Access Compliance Report

Public Rights-of-Way

| Intersection ID: 12517 | Main Street: N_SHARON_AMITY_RD | Cross Street: SHAMROCK_DR | Location: W |
| ADA ID: 4F7A0EFBAA38 | Ramp Type: Perp | Initial Pass/Fail: Fail | Overall Compliance: No |

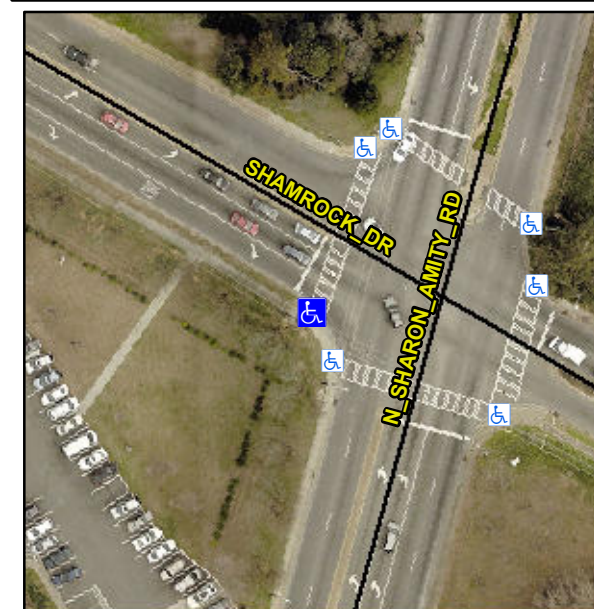
Not Found, R304.5.1

| Compliance | Description | Data | Compliance | Description | Data |
|------------|-----------------------|-------|------------|-----------------------------|------|
| No | Ramp Width (in) | 47.0 | Yes | Ramp XSlope (%) | 0.2 |

Remove & Replace Entire Ramp.
